Council Reference: A006904370
Attention: Kayal Chandrasekar

RE: Response to Information Request – Minor Change to Material Change of Use for a Multiple Dwelling at 3 - 9 Byron Street, Bulimba

Figure 1: Proposed Driveway Sight Line (Source: MODE)

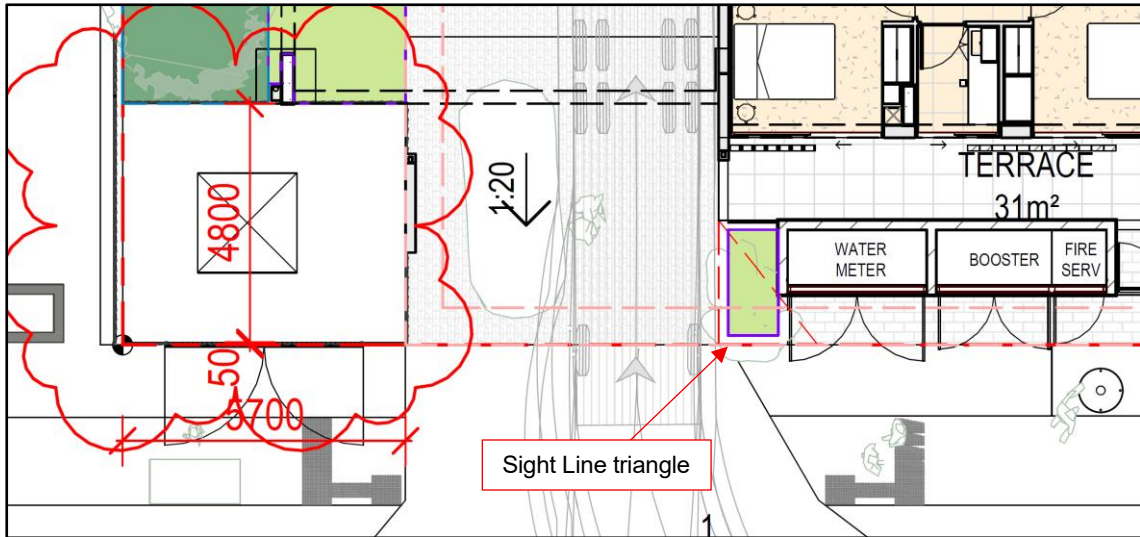
a. Submit amended design to relocate the water meters, booster, and fire services cupboard parallel with the driveway or inside of the lobby area. The design of the assembly to also consider higher quality architectural outcome using variation in materials, finishes and detailing.

c. Submit amended plans showing minimum width for the proposed concrete slab for the pad mount transformer to allow growth of climbing plants on the battened enclosure, minimising the visual impact on the street.

Due to the current Australian Standards for location of Fire Services, specifically AS2419.1:2021 Clause 7.3.3(d)(i), the booster and fire cabinets are required to achieve a 10m separation from high voltage equipment. As such, achieving a 10 m separation from the PMT along the driveway would require the booster to be located within the site. However, AS 2419.1:2021 Clause 7.36.3(a) stipulates that the booster cabinet must be located no more than 10 m from a hardstand area. In this instance, the hardstand is the street; therefore, the booster must be positioned within 10 m of the street frontage. Any location along the driveway that achieves a separation greater than 10 m from the PMT would consequently be situated more than 10 m from the hardstand.

Furthermore, Clause 7.36.3(c) of AS 2419.1:2021 requires that the booster outlets be oriented towards the hardstand. Accordingly, the booster cabinet must face the street and cannot be oriented toward the driveway.

We also note the requirement for cupboards to be offset from the driveway to ensure traffic sight lines are provided in accordance with Australian Standards.

Figure 5: Lodged Level 4 Plan (Top) vs Amended Level 4 Plan (Bottom) (Source: MODE)

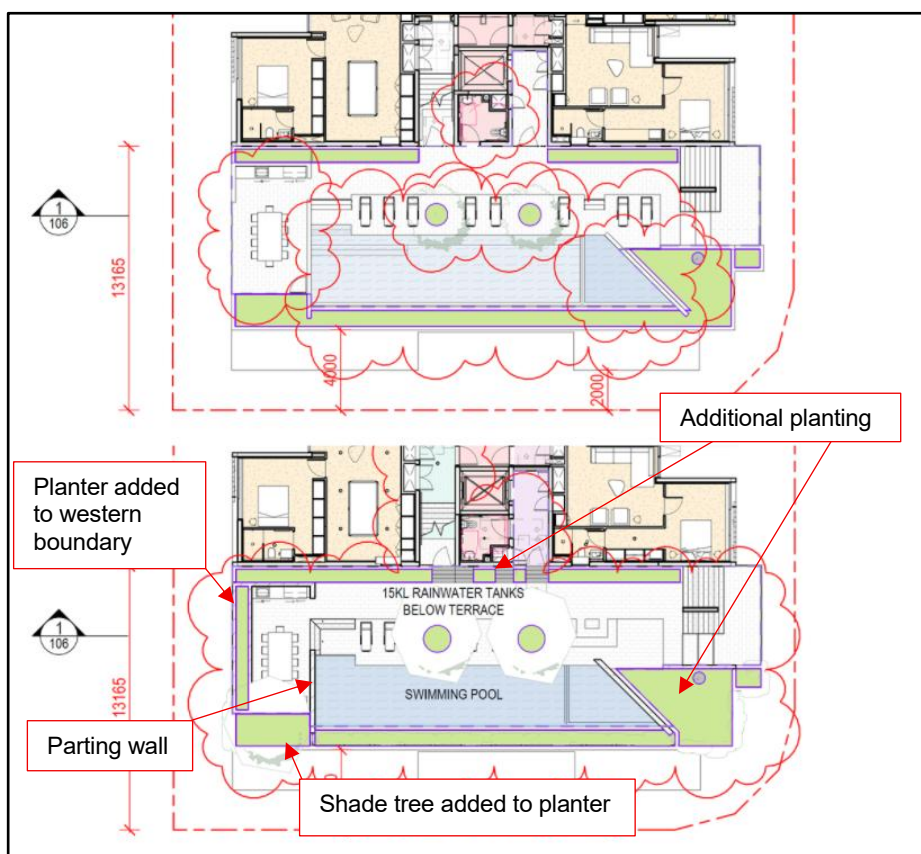
4. The proposed changes to the communal open space at Level 4 diminish the landscape offering which doesn't go towards balancing the shade offering or provide a pleasant outlook as required by PO8 and AO30.1/ PO30 of the Multiple dwelling code. Submit amended plans showing a balance of built and natural shade to the communal open space to provide future residents with a functional and useable space.

5. Submit amended Level 4 floor plans showing soft landscaping along the western edge at the interface with the adjoining development, consistent with the approved plans (Council ref: A006702114), to comply with PO8, PO28 and AO31.3/PO31 and of the Multiple dwelling code.

Notwithstanding, in response to item 4, the applicant has improved the landscaping outcome for the communal area and increased the total Level 4 landscaping to 56.5m². Specifically, the following amendments have been made, and are shown in Figure 4:

- provision of planter along western boundary providing screening and landscaping;
- increase in depth of southern planter to 1200mm to accommodate a shade tree for the seating area.
- Provision of parting wall, with a large opening, between seating area and pool to improve shading and privacy, forming a more private 'dining terrace' in order to promote a range of uses. This creates flexibility of use by residents and maintains shared views.
- Pool size reduced to add landscaping.
- Additional landscape planters added to communal area entrance.

Figure 6: Chute Section (Source: MODE)

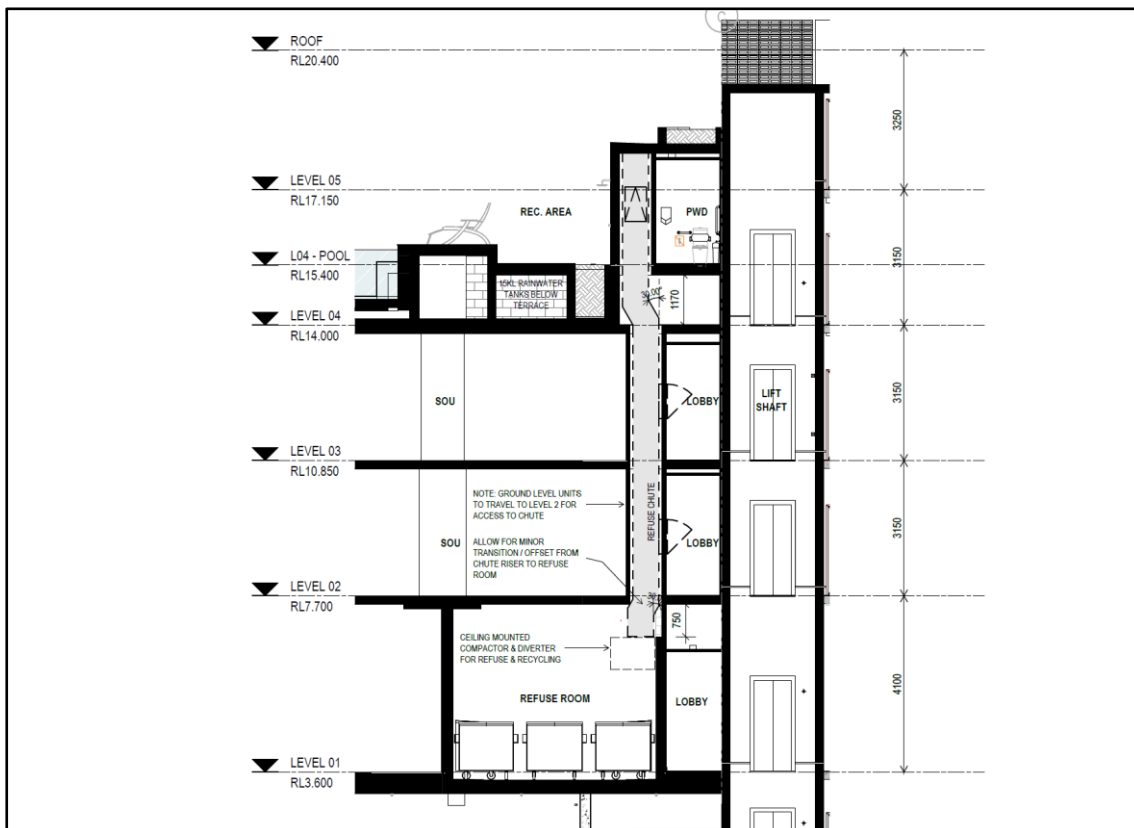
7. The changed proposal has removed the residents' access to the Bin room, therefore requiring residents to go down to the basement and up the stairs to dispose of their recycling. Provide amended plans in accordance with AO32/PO32 of the Multiple dwelling code and AO8.1 & AO8.2/PO8 of the Infrastructure design code to show the following:

- a. A diverter to provide convenient disposal of recycling for residents and to achieve source separation between general refuse and comingled recycling
- b. Include details of the refuse storage room including chute and the dimensions of the bin room, gradients, aisle width and reference to the speed bump

Please refer to the Waste Management Response Letter prepared by ITE Consulting. A chute diverter has been provided within the bin room to separate general waste and recycling waste. Ground level residents will utilise the bin chutes on Level 2 to dispose of general and recycling waste, which will be separated by the diverter (Figure 6).
